**TOPOGRAPHIC SURVEY
SEASPECT SHORT PLAT
JOHN KAHAN**

NO.	DESCRIPTION	DATE
3	PERMIT REVISION	04.19.22
4	PERMIT REVISION 2	06.10.22
5	PERMIT REVISION 3	08.30.22

CLARKSON RESIDENCE
8163 W MERCER WAY
 City of Mercer Island, Washington

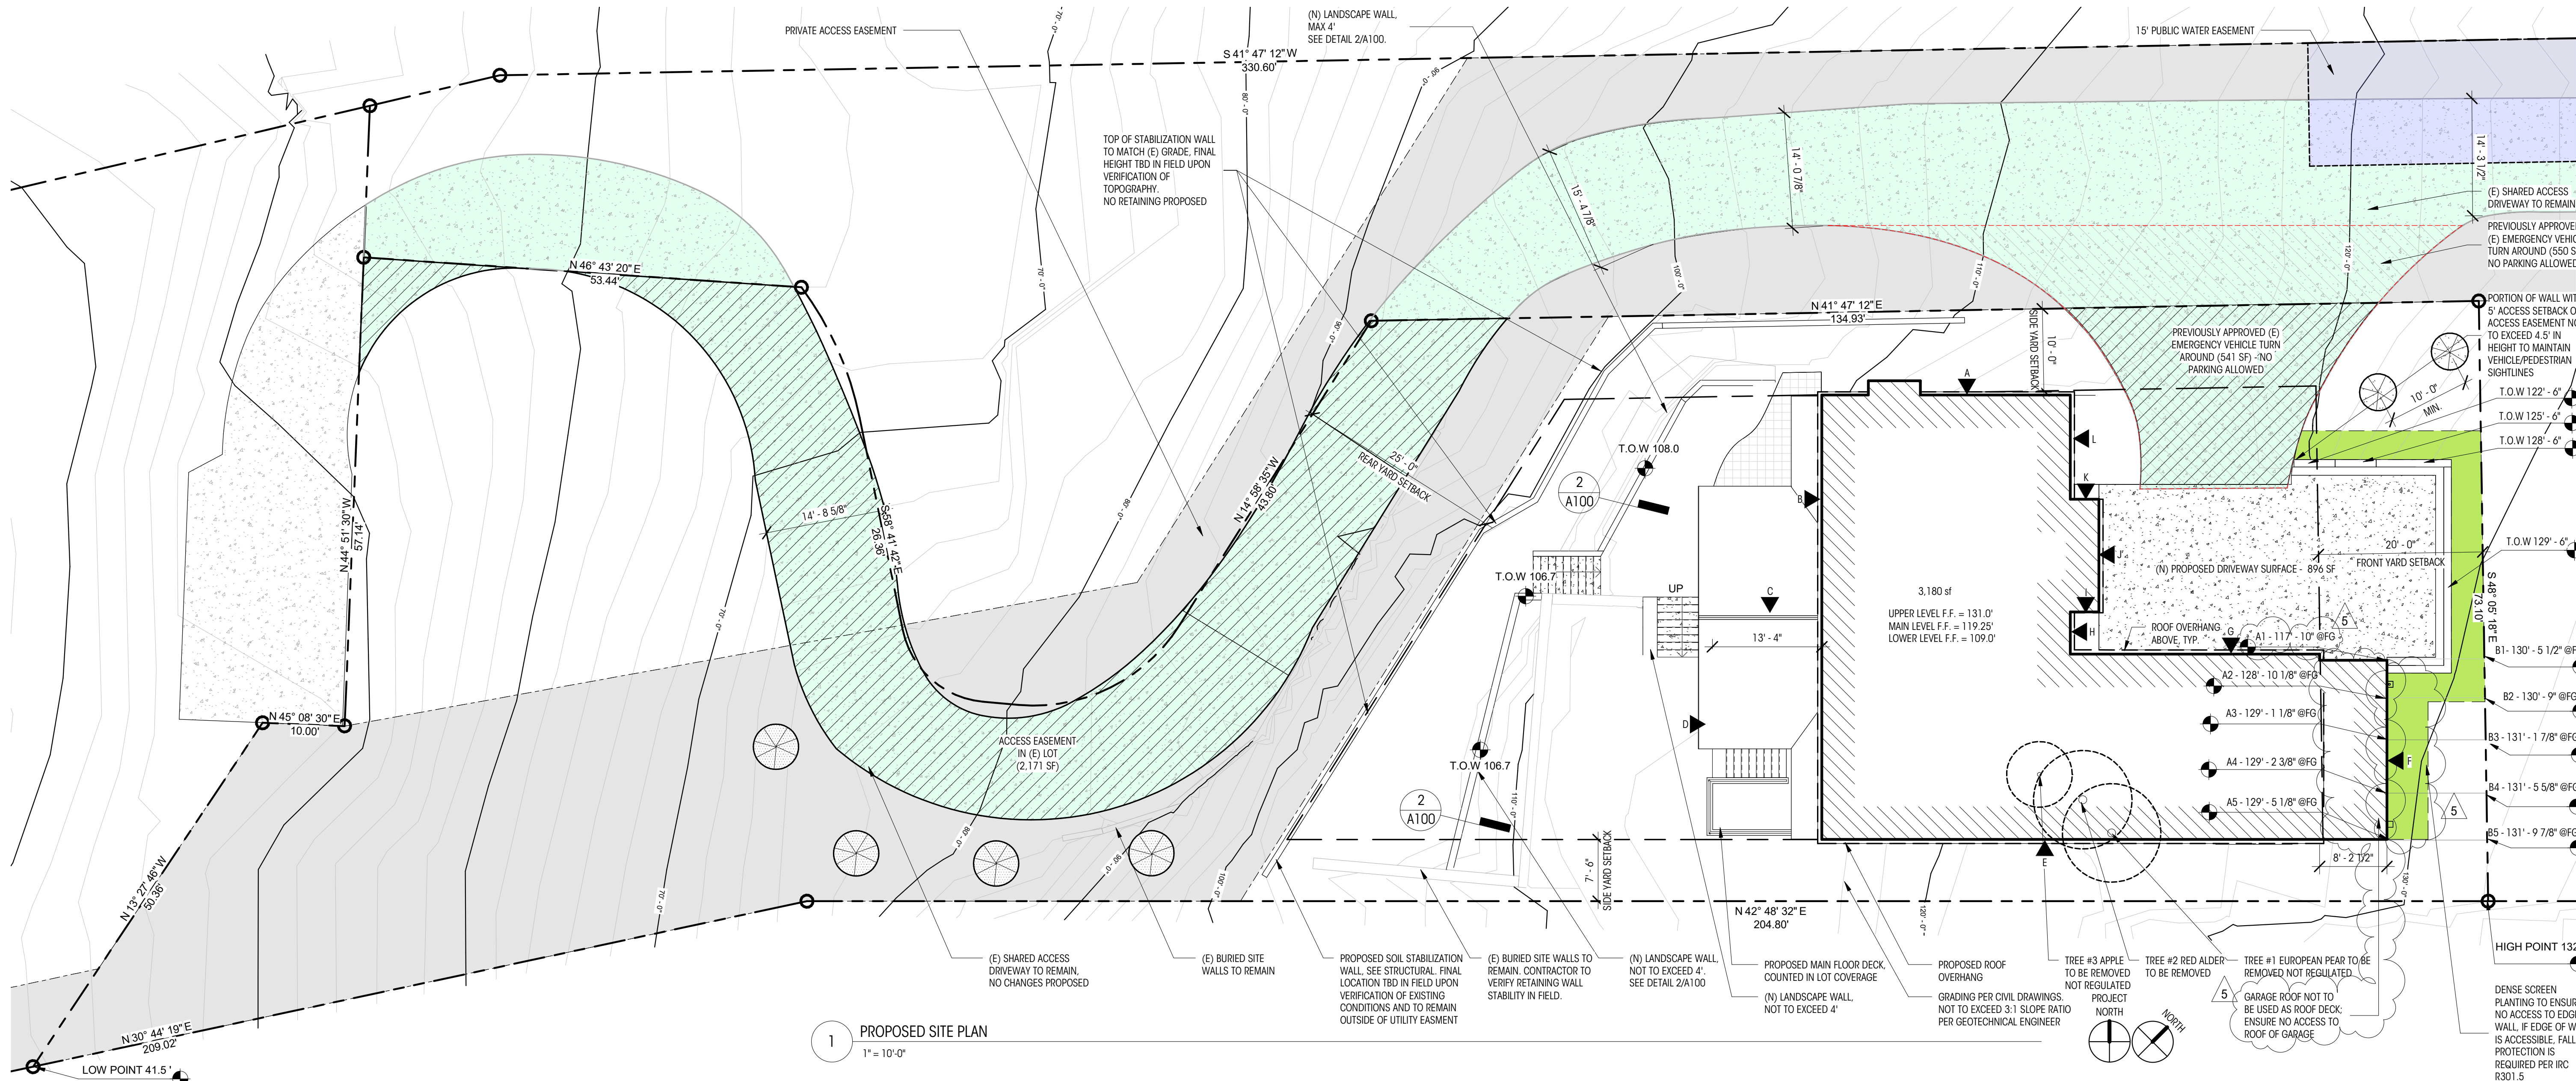
- NO CHANGE TO ROOF OVERHANGS AT SETBACKS
- NO CHANGE TO VARIABLE SIDE YARD SETBACKS
- NO CHANGE DOWNHILL SLOPE GRADE OR RIDGE HEIGHT
- EXTEND GARAGE EAST INTO FRONT YARD SETBACK AS ALLOWED BY CODE 19.02.040.D

- FRONT YARD ENCROACHMENT CALCULATIONS ADDED
- SHIFT OF PARKING RETAINING WALLS TO NORTH AND SOUTH
- CHANGE ROOF OF AND EXTEND WESTERN PATIO TO THE WEST AND SOUTH

- CHANGE IN SOIL RETENTION WALL, PREVIOUSLY AS PART OF FOUNDATION SYSTEM, NOW MOVED TO WESTERN YARD ADJACENT TO ROAD IN ORDER TO ALLOW FOR LANDSCAPE WORK

- REVISED LEGAL DESCRIPTION AS A RESULT OF PROPERTY SALE
- CHANGE TO LOT COVERAGE AS A RESULT OF SHIFTED PARKING RETAINING & EXTENDED COVERED DECK
- CHANGES TO HARDSCAPE CALCULATIONS AS A RESULT OF SOIL STABILIZATION WALL, PATIO EXTENSION AND SITE STAIRS

- CHANGES TO GFA AS A RESULT OF EXTENDED GARAGE AND EXTENDED COVERED DECK
- REVISED LOCATION TO REPLACEMENT TREES
- CHANGE TO ABE AS A RESULT OF EXTENDED GARAGE AND EXTENDED COVERED DECK

- GRAPHICS/PATTERNS/HATCHES HAVE BEEN COORDINATED FOR CONSISTENCY
- MEETS AND BOUNDS ADDED TO ALL PROPERTY LINES

1 PROPOSED SITE SETBACK & BUILDING PAD PLAN
 1" = 10'-0"

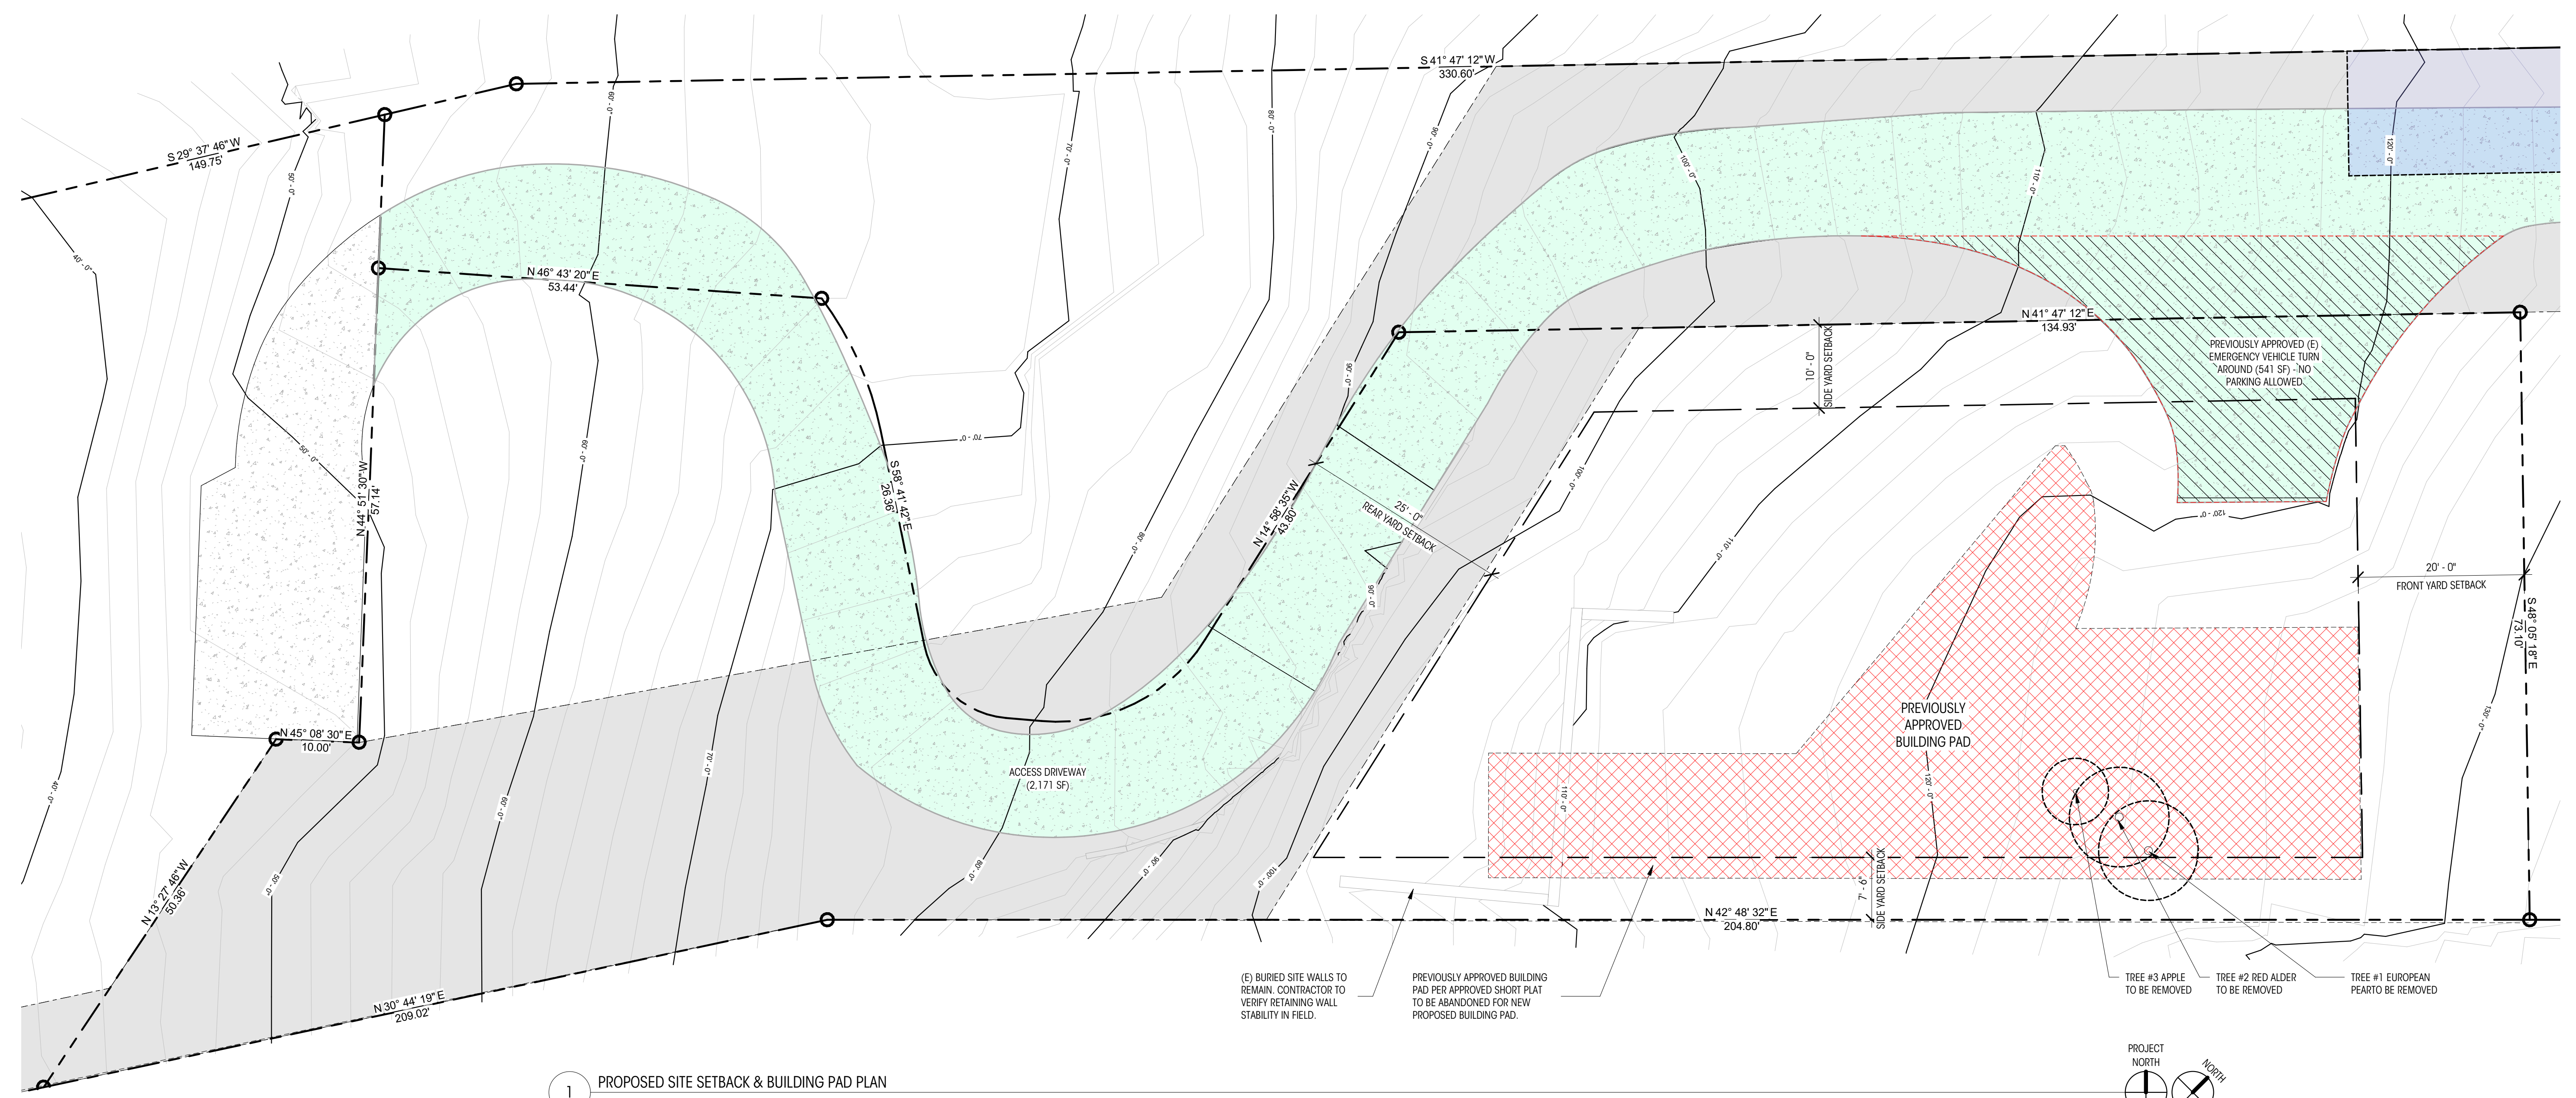
- CHANGE IN SOIL RETENTION WALL: PREVIOUSLY AS PART OF THE FOUNDATION SYSTEM, NOW MOVED TO WESTERN YARD ADJACENT TO ROAD IN ORDER TO ALLOW FOR LANDSCAPE WORK
- REVISED FOUNDATION AS A RESULT OF SOIL STABILIZATION WALL LOCATION MOVE.
- LEVEL CHANGES: DRIVEWAY & GARAGE LEVEL DROP BY 15"; BASEMENT LEVEL DROP BY 12".
- GRAPHICS/PATTERNS/HATCHES HAVE BEEN COORDINATED FOR CONSISTENCY
- ADDITIONAL GRADING PROPOSED AS A RESULT OF THE ADDED LANDSCAPE WALLS.
